Additions and Renovations
Platt Technical High School
Milford, CT

ADDENDUM NO. 3

August 2, 2019

RA3-09

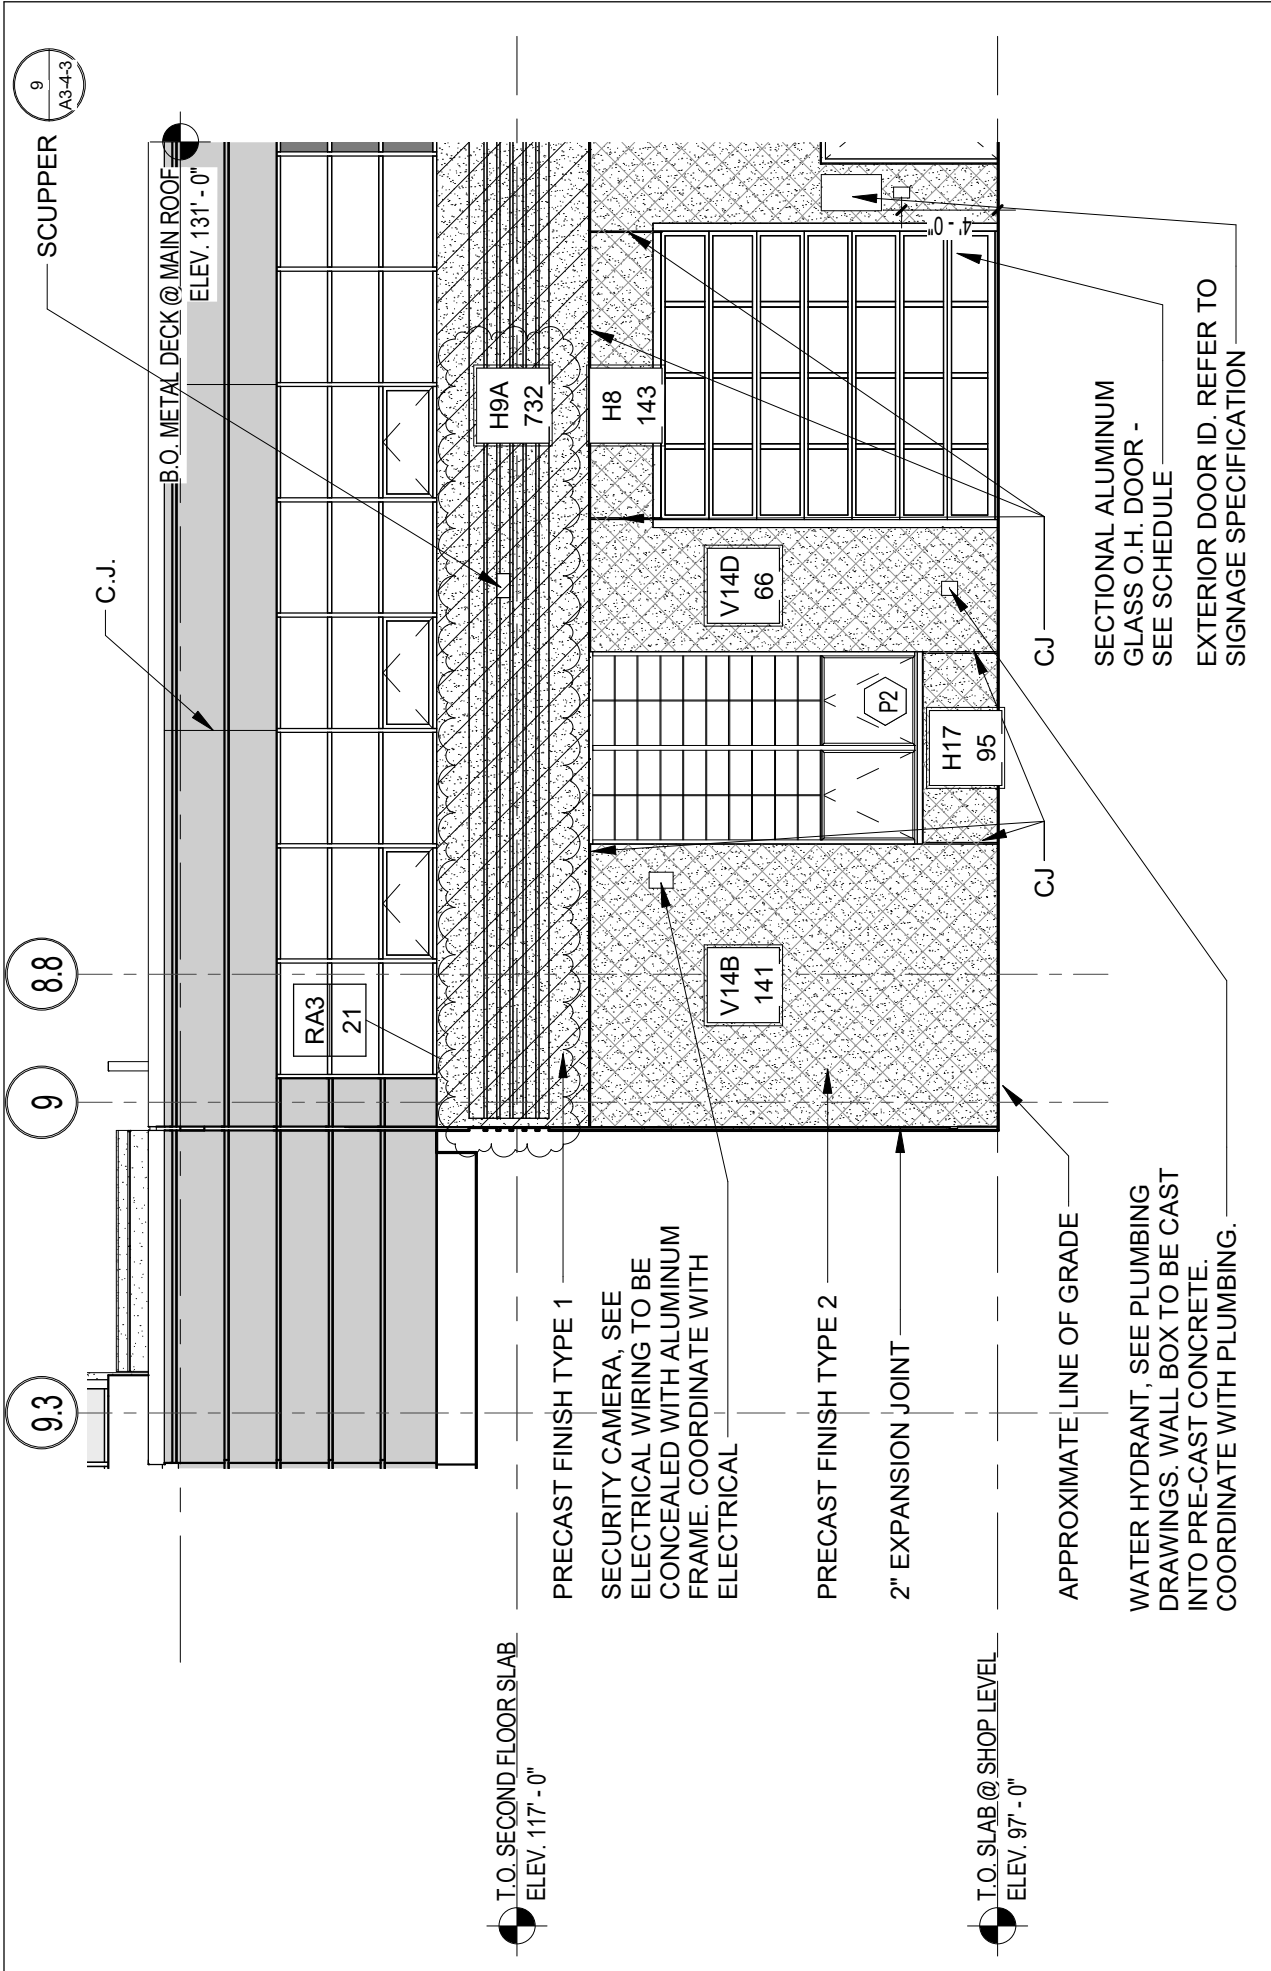
- ADD 3-062 DRAWING A2-2-3 – DOOR, FRAME AND BORROWED LIGHT TYPES**
Revised dimensions of door Types AL1 & AL2 per Sketch RA3-09.
- ADD 3-063 DRAWING A6-3-4 – CURTAIN WALL AND STOREFRONT TYPES**
Revision RA3-1:
Frame Type SF5: Revised detail tag.
Frame Type CW27: Added steel girt note.
Frame Type CW29: Added note for opening in panel.
Frame Type CW35 (*previously SF3*): Revised frame type.

1 SECOND FLOOR PLAN - AREA A
1/8" = 1'-0"

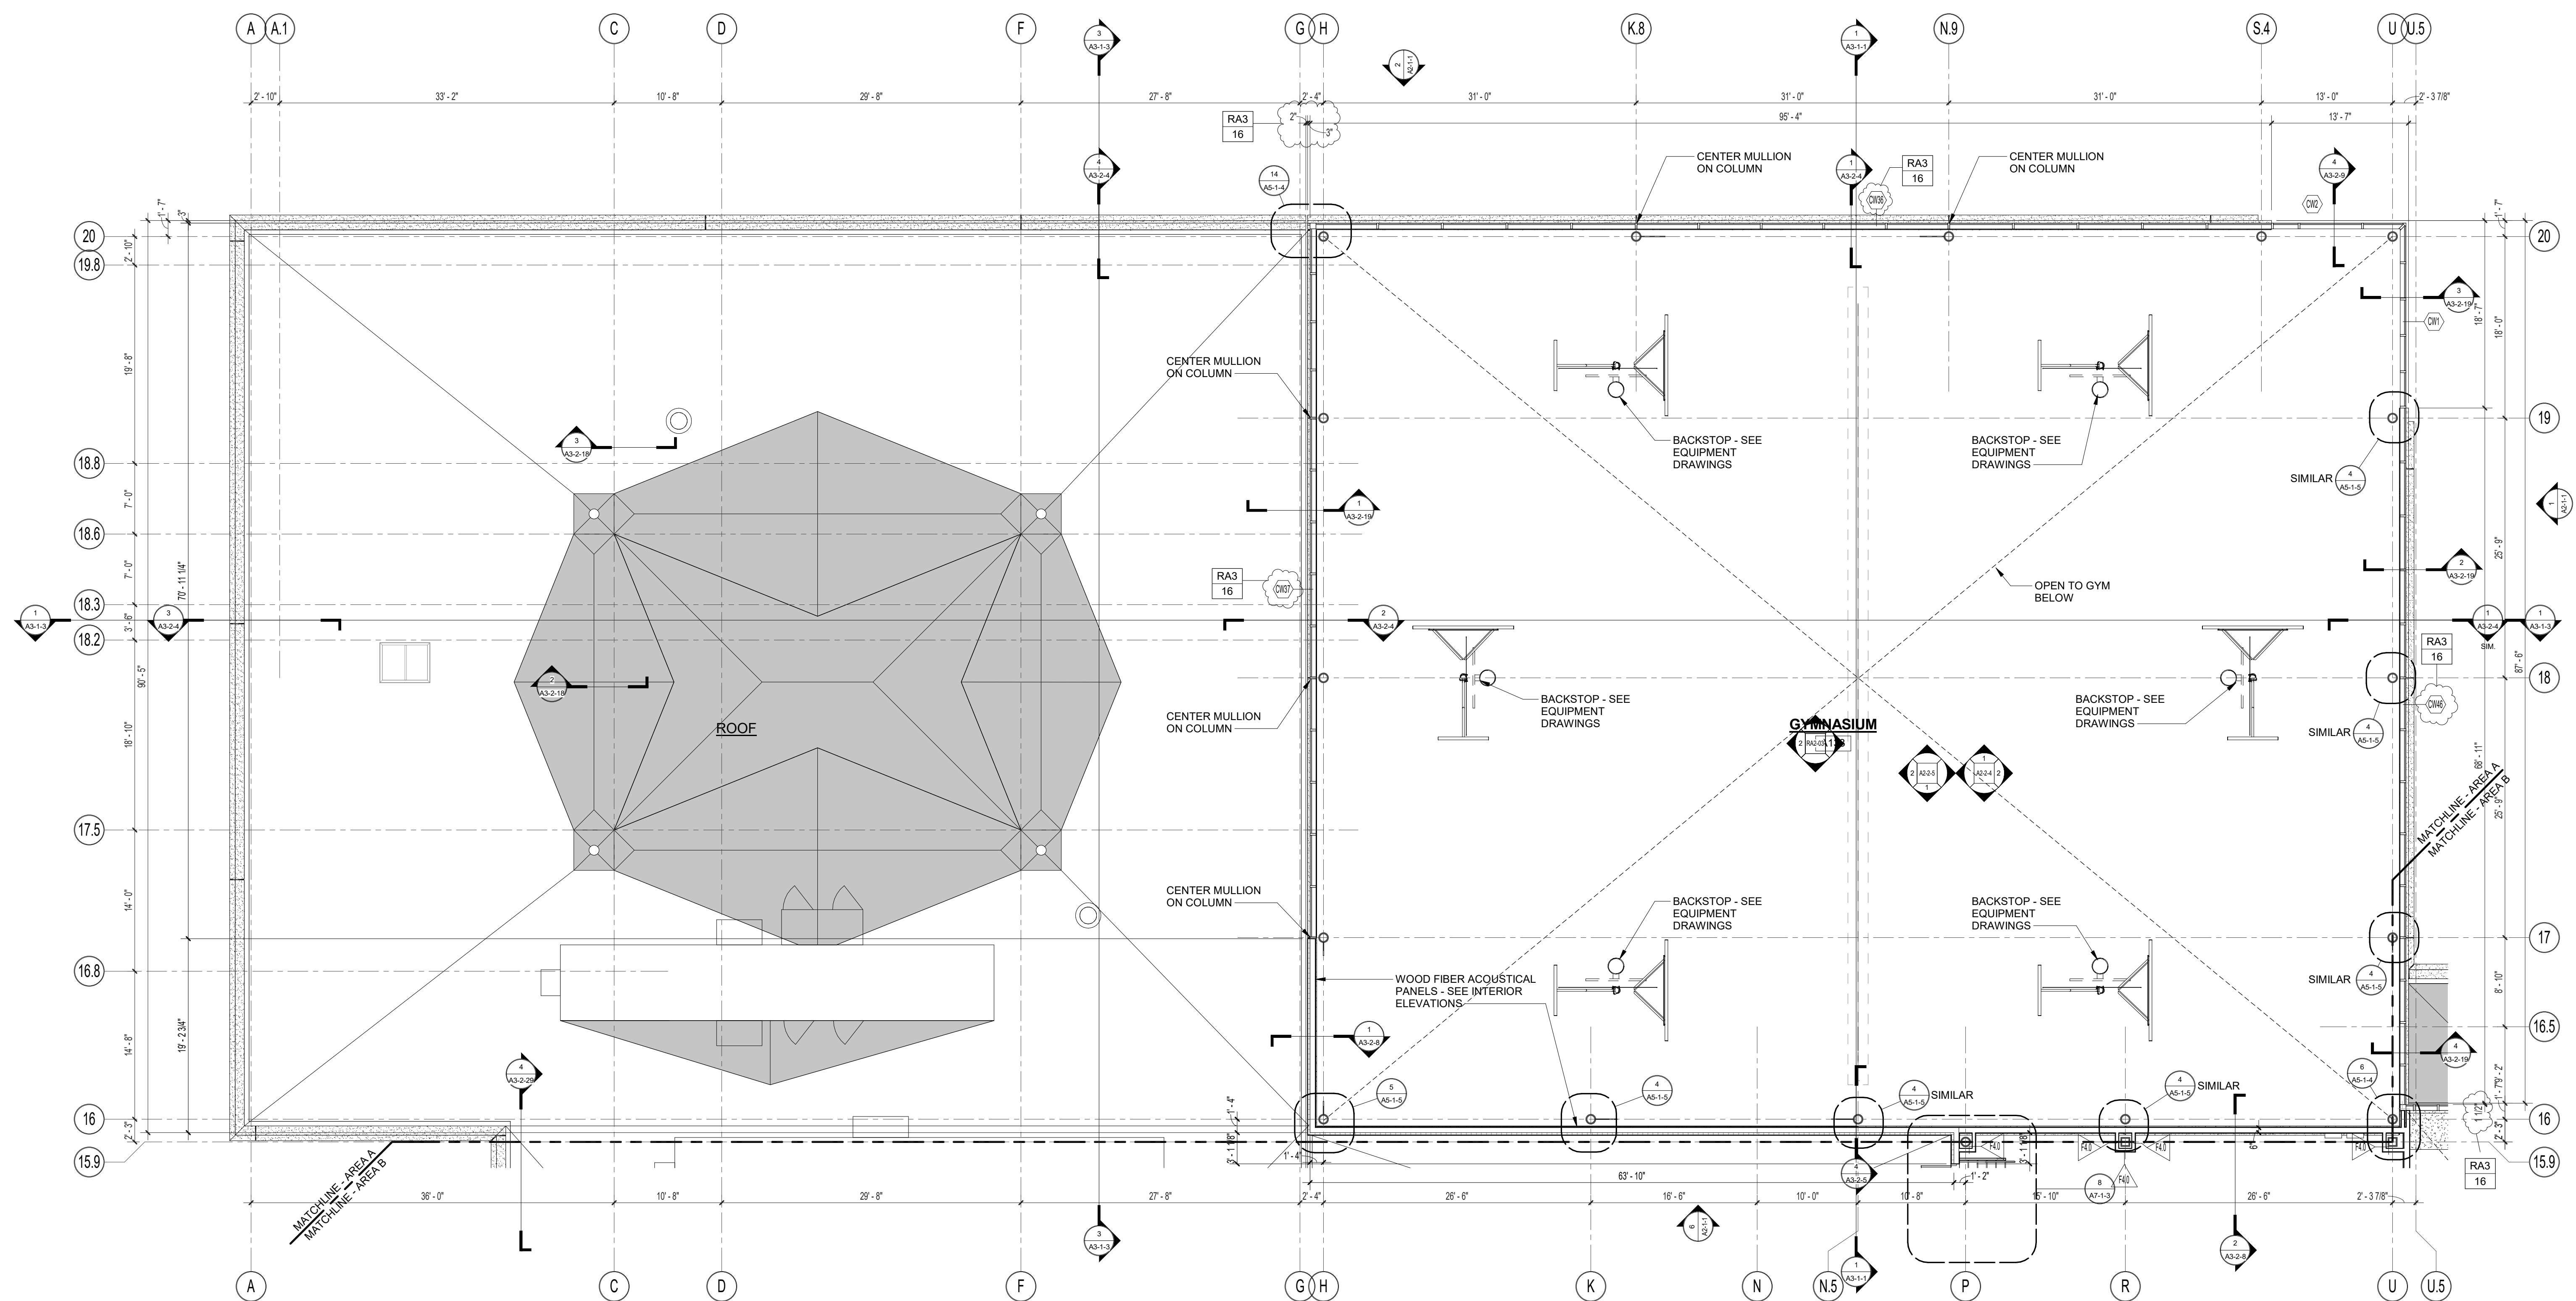
- ADD 3-051** **DRAWING A1-1-2A – CLERESTORY PLAN – AREA A**
Revision RA3-16:
Revised Aluminum Frame Tag “SF7” to read “CW36” and associated dimensions.
Revised Aluminum Frame Tag “SF8” to read “CW37.”
Revised Aluminum Frame Tag “SF20” to read “CW46” and associated dimensions.

1 SECOND FLOOR PLAN - D
1/8" = 1'-0"

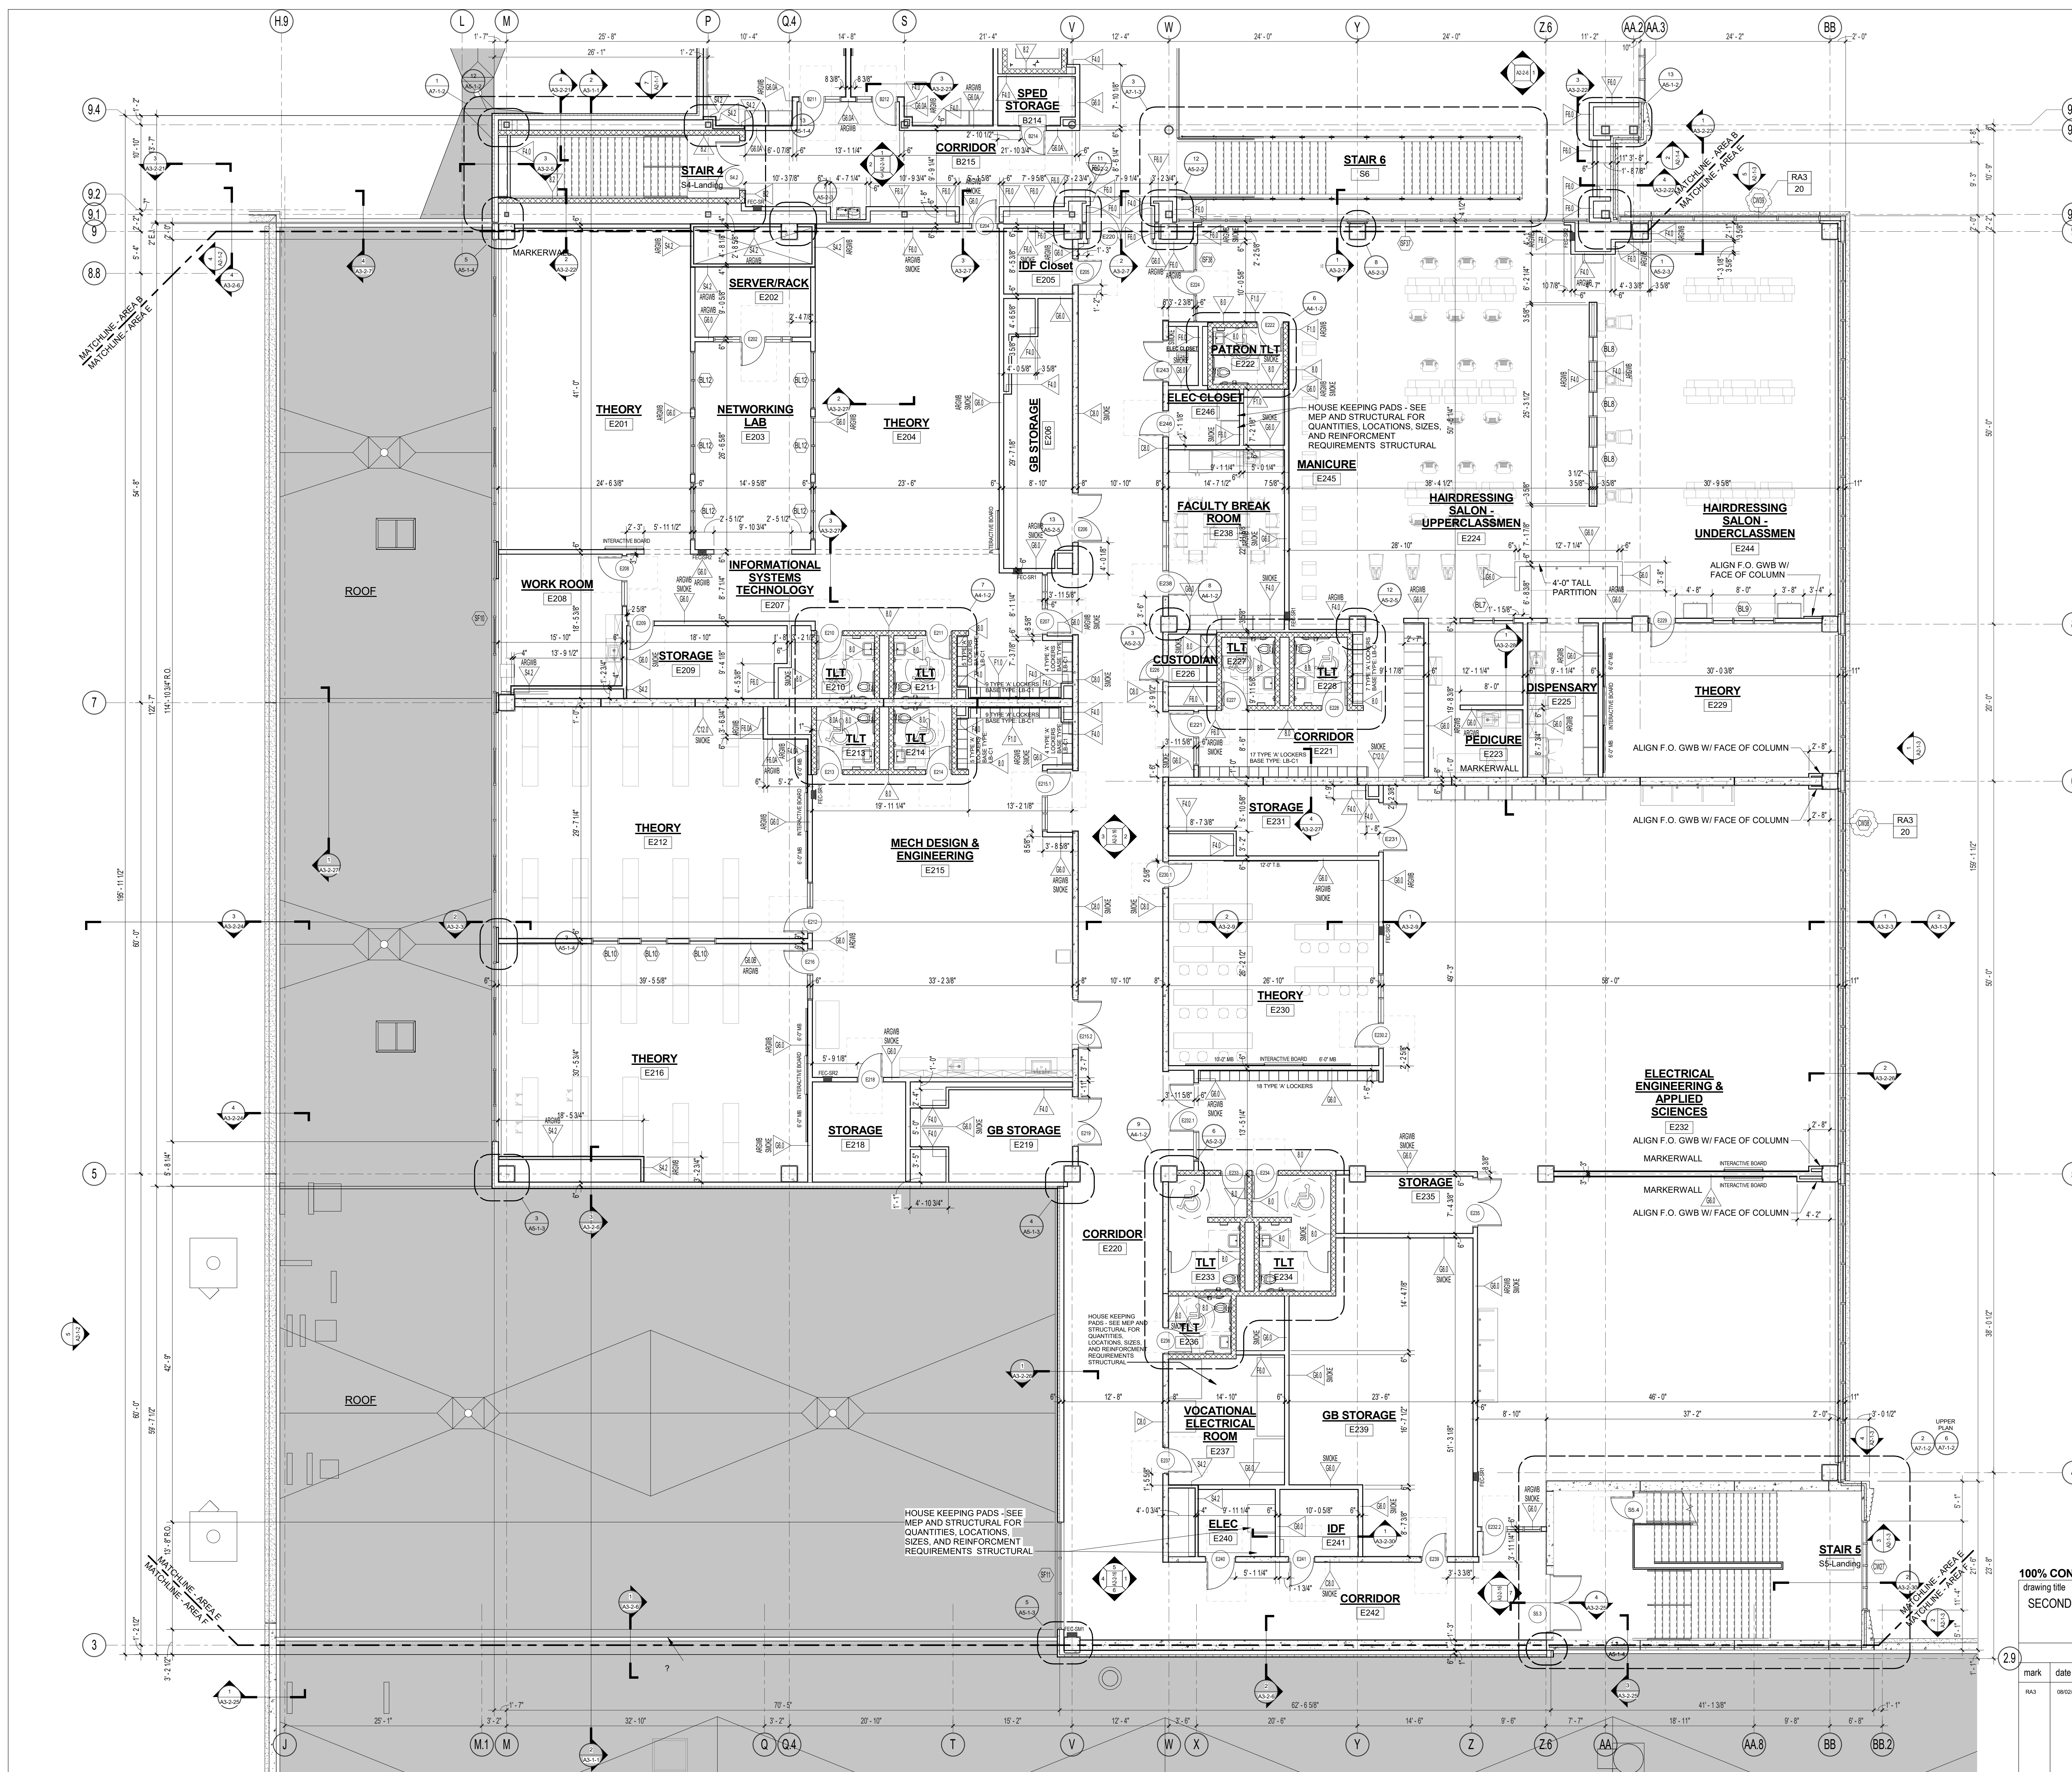
- ADD 3-054** **DRAWING A1-1-2D – SECOND FLOOR PLAN – AREA D**
Revision RA3-19:
Revised Aluminum Frame Tag “SF15” to read “CW41.”
- ADD 3-055** **DRAWING A1-1-2E – SECOND FLOOR PLAN – AREA E**
Revision RA3-20:
Revised Aluminum Frame Tag “SF12” to read “CW38.”
Revised Aluminum Frame Tag “SF13” to read “CW39.”
